# APPLICATION FOR PERMISSION UNDER SECTION 16 OF THE TOWN PLANNING ORDINANCE (CAP. 131)

For Official Use Only 請勿填寫此欄	Application No. 申請編號	A/NE-MUP/220
	Date Received 收到日期	2025-11-10

(a) Proposed use(s)/development 擬議用途/發展	擬議臨時物流中心及相關填土工程 Proposed Temporary Logistics Centre and Associated Filling of Land  (Please illustrate the details of the proposal on a layout plan) (請用平面圖說明擬議詳情)

**Temporary Logistics Centre and Associated Filling of Land  
Various Lots and Adjoining Government Land, Sha Tau Kok, N.T.  
( Application No. A/NE-MUP/220 )**

Proposed Drainage Layout Plan- Roof Level

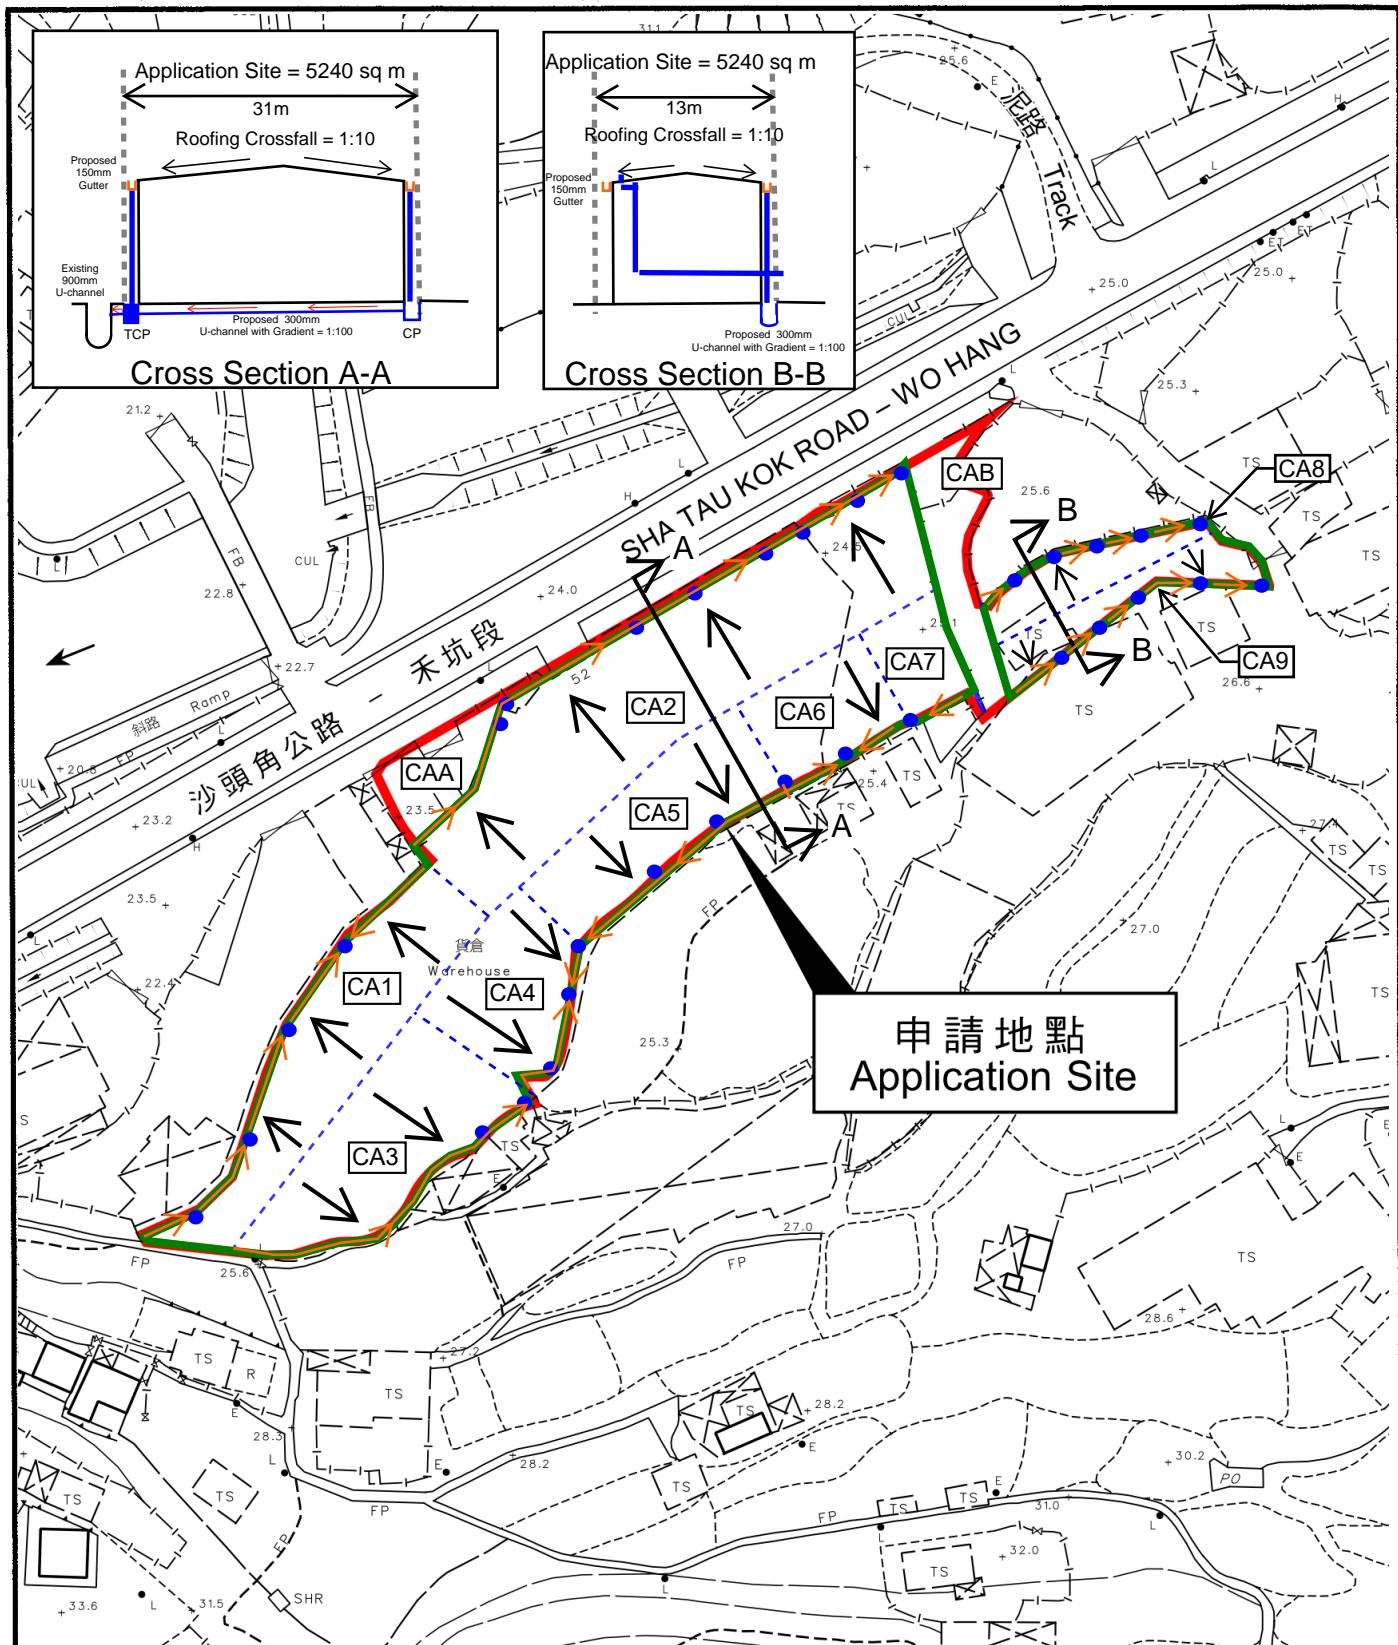
- no objection to the application from public drainage viewpoint;
- the submitted drainage proposal is identical to that submitted under planning application No. A/NE-MUP/193, which was considered unacceptable. Hence, should the application be approved, approval conditions to request the applicant to submit and implement a drainage proposal for the Site should be included to ensure that the applied use will not cause adverse drainage impact on the adjacent areas. The drainage facilities should be properly maintained at all times during the planning approval period and rectified if they are found inadequate/ineffective during operation;

- (i) the drainage system should be rectified if they are found inadequate/ineffective during operation;
- (ii) the applicant should construct and maintain the proposed drainage facilities whether within or outside the Site at his own expense;
- (iii) the Site is in an area where public sewerage connection is available. Environmental Protection Department should be consulted regarding the sewage impact assessment and sewage treatment/disposal facilities for the applied use; and
- (iv) the submitted drainage proposal is identical to that submitted under planning application No. A/NE-MUP/193, which was considered unacceptable. The applicant should address his previous comments and submit a revised drainage proposal for his review;

Proposed Automatic Sprinkler and Modified Hose Reel System

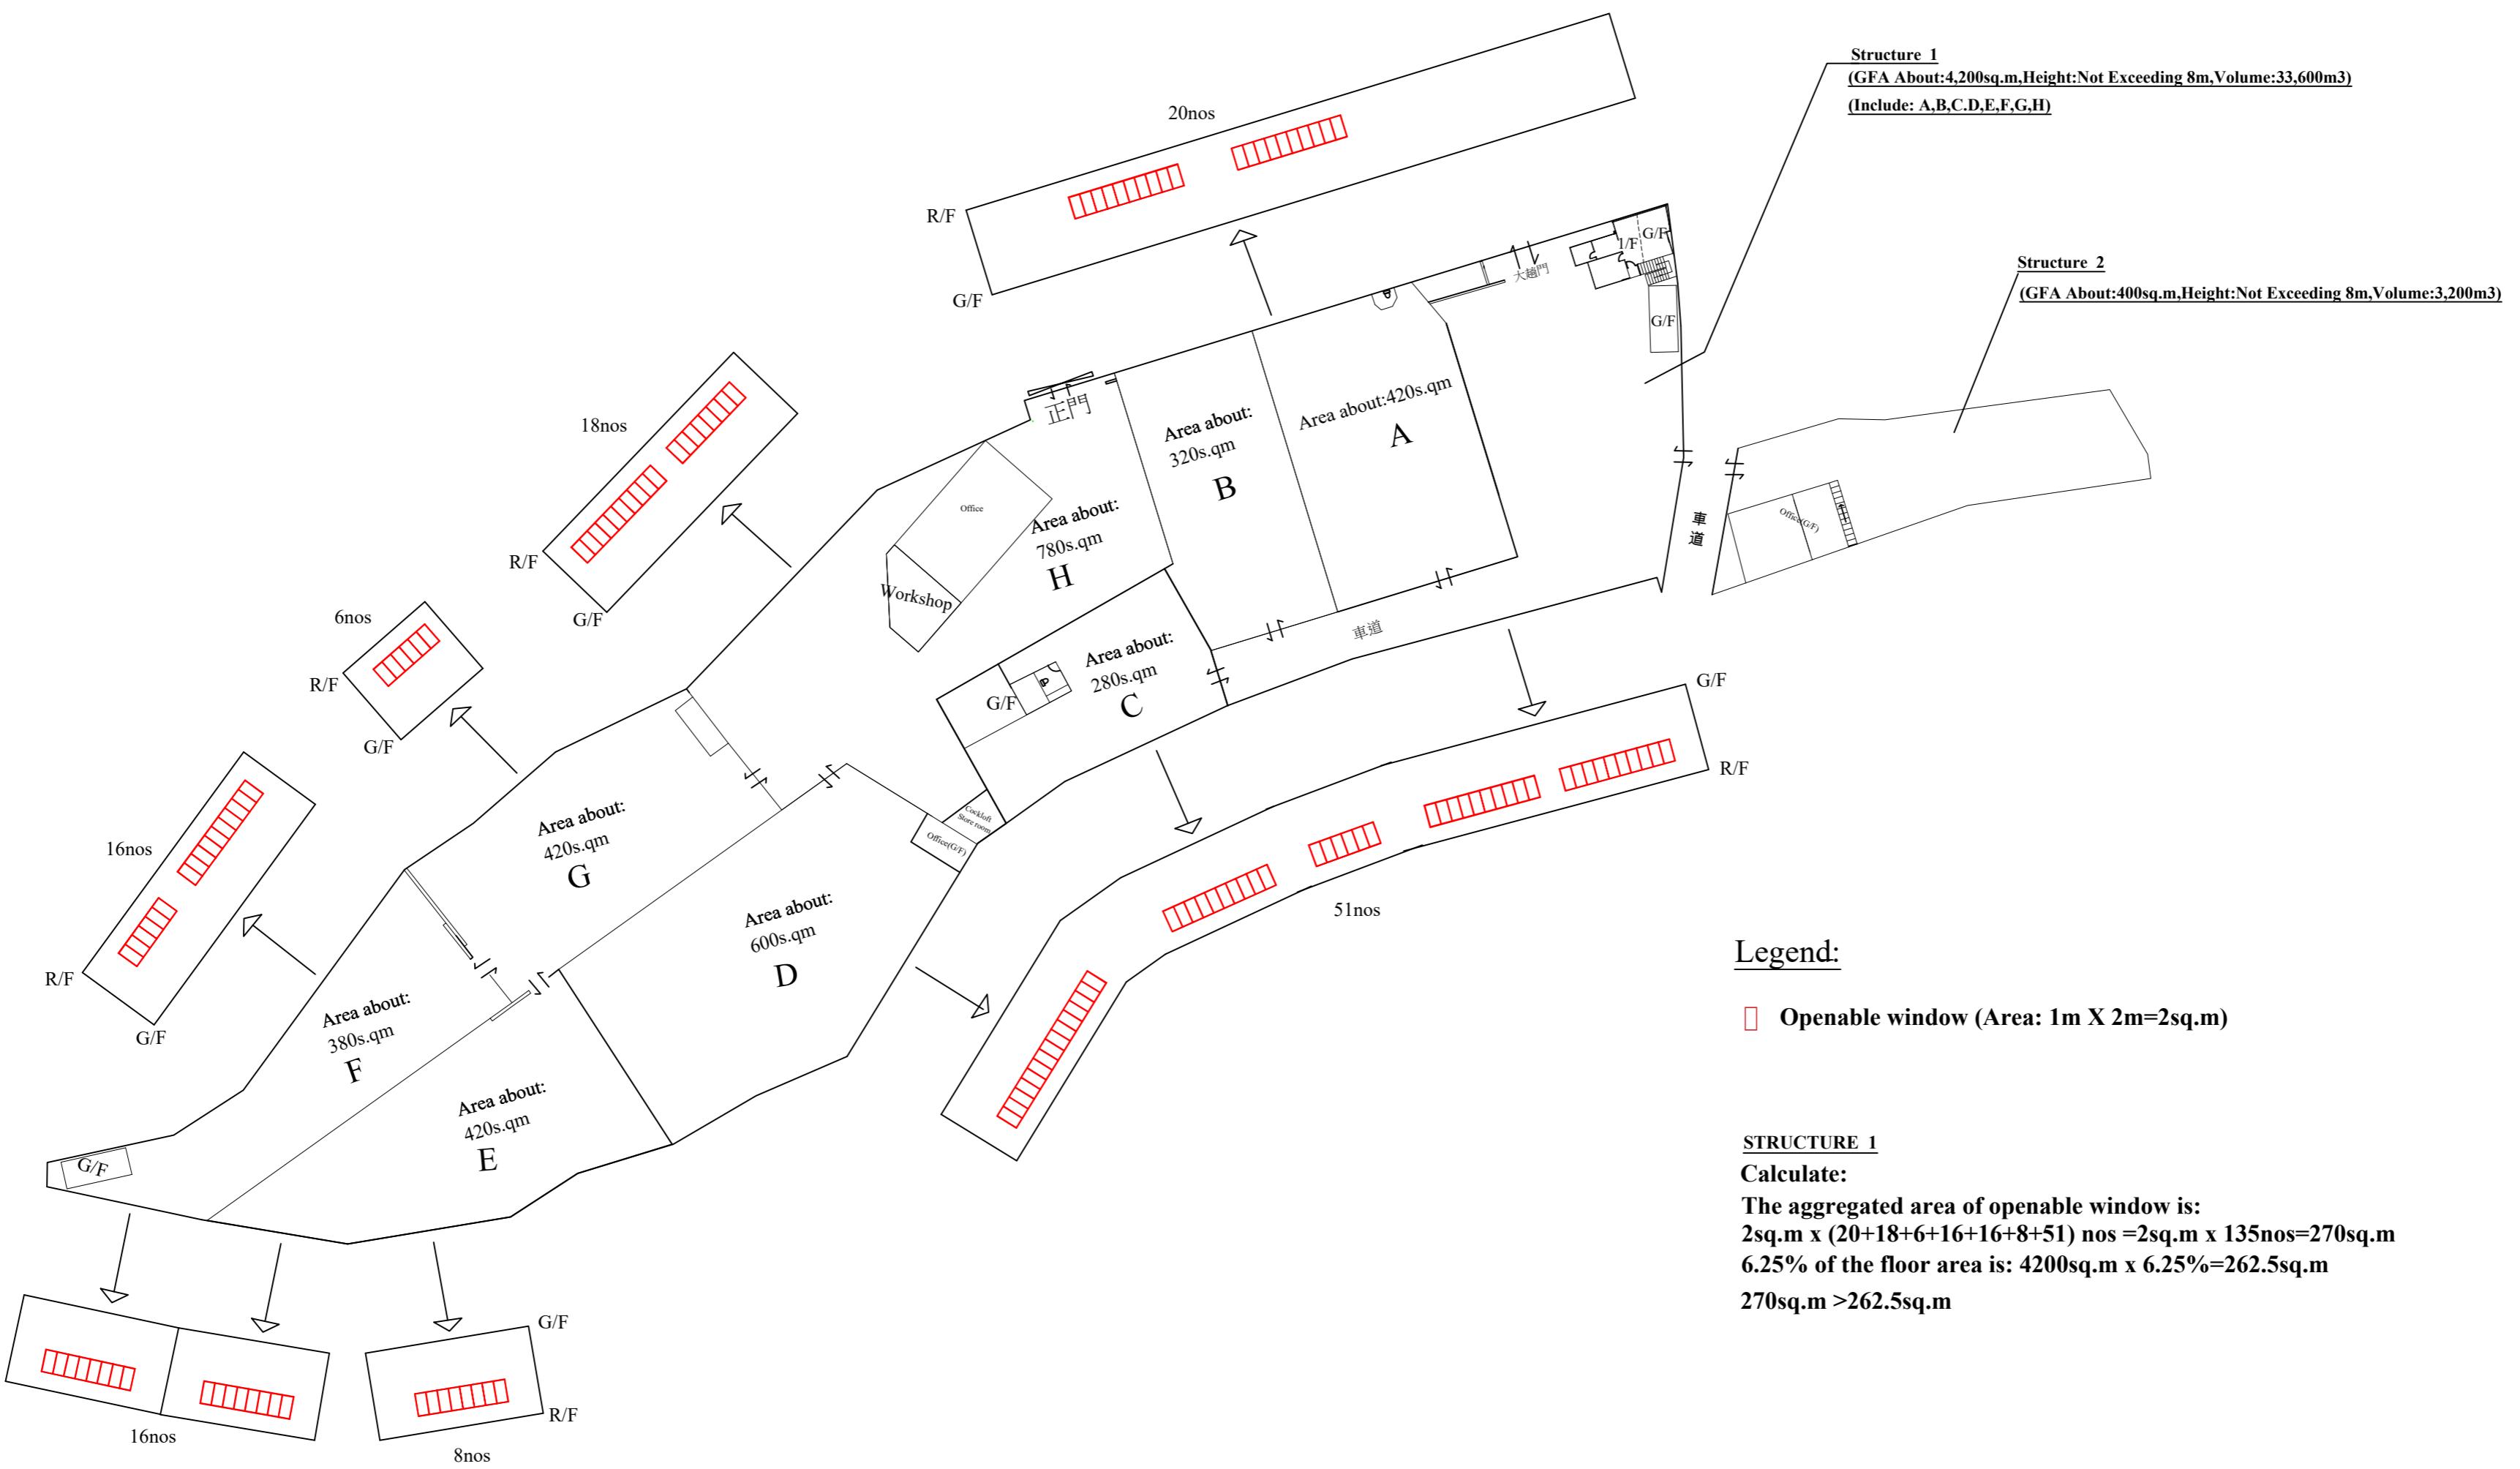
- (i) in consideration of the design/nature of the proposal, fire service installations (FSIs) are anticipated to be required. Therefore, the applicant is advised to submit relevant layout plans incorporated with the proposed FSIs to his department for approval. In addition, the applicant should also be advised on the following points:
  - the layout plans should be drawn to scale and depicted with dimensions and nature of occupancy;

- the location of the proposed FSIs to be installed should be clearly marked on the layout plans; and

4. An Automatic sprinkler system supplied by 135,000L sprinkler water tank and Hazard class: OH III should be provided to the structure 1 & structure 2 in accordance with BS EN 12845: 2015 and FSD circular 5/2020 . The sprinkler water tank, sprinkler pump room, sprinkler inlet, sprinkler control valve group shall be clearly marked on plans.

6. A modified hose reel system supplied by a 2000 litre FS water tank shall be provided There shall be sufficient hose reels to ensure that every part of each building can be reached by a length of not more than 30m of hose reel tubing. The FS water tank, FS pump room and hose reel shall be clearly marked on plans.
